STATE OF NORTH CAROLINA  
DEPARTMENT OF TRANSPORTATION

**Addendum No. 1**

Contract No.: C 202853  
TIP No.: U-2800  
County: Forsyth  
Project Description: SR 2601 (Macy Grove Road) from south of SR 4319 (Industrial Park Drive) to north of SR 1005 (East Mountain Street)

RE: Addendum No. 1 to Final RFP

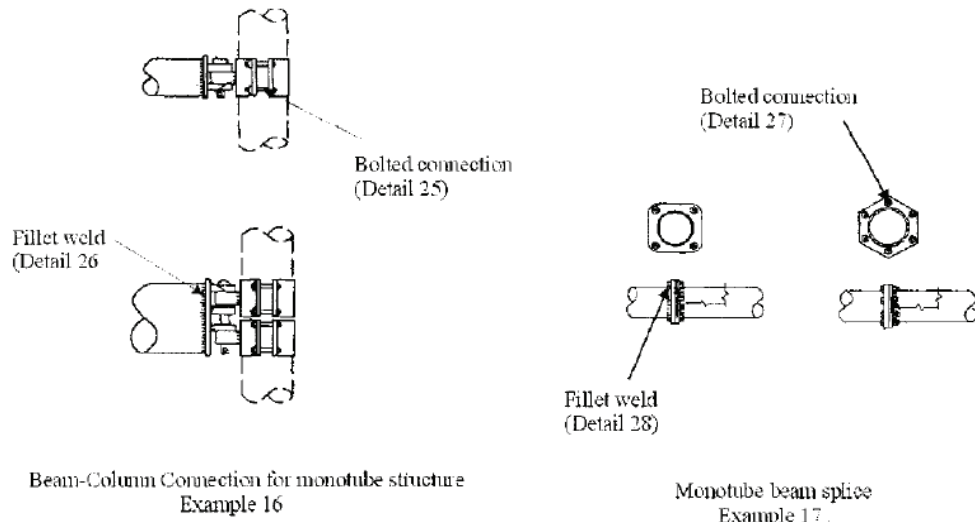
- The base plate thickness for all uprights and poles shall be a minimum of 2" but not less than that determined by the following criteria and design.

Case 1 Circular or rectangular solid base plates with the upright pole welded to the top surface of base plate with full penetration butt weld, and where no stiffeners are provided. A base plate with a small center hole, which is less than 1/5 of the upright diameter, and located concentrically with the upright pole, may be considered as a solid base plate.

The magnitude of bending moment in the base plate, induced by the anchoring force of each anchor bolt shall be calculated as  $M = (P \times D_1) / 2$ .

Case 2 Circular or rectangular base plate with the upright pole socketed into and attached to the base plate with two lines of fillet weld, and where no stiffeners are provided, or any base plate with a center hole that is larger in diameter than 1/5 of the upright diameter

The magnitude of bending moment induced by the anchoring force of each anchor bolt shall be calculated as  $M = P \times D_2$ .

- M - bending moment at the critical section of the base plate induced by one anchor bolt
- P - anchoring force of each anchor bolt
- $D_1$  - horizontal distance between the center of the anchor bolt and the outer face of the upright, or the difference between the radius of the bolt circle and the outside radius of the upright

- D<sub>2</sub>. horizontal distance between the face of the upright and the face of the anchor bolt nut
- The critical section shall be located at the face of the anchor bolt and perpendicular to the radius of the bolt circle. The overlapped part of two adjacent critical sections shall be considered ineffective.

- The thickness of Case 1 base plate shall not be less than that calculated based on formula for Case 2.
- Uprights, foundations, and trusses that support overhead signs shall be designed in accordance with the Overhead and Dynamic Message Sign Foundations Project Special Provision for the effects of torsion. Torsion shall be considered from dead load eccentricity of these attachments, as well as for attachments such as walkways, supporting brackets, lights, etc., that add to the torsion in the assembly. Truss vertical and horizontal truss diagonals in particular and any other assembly members shall be appropriately sized for these loads.
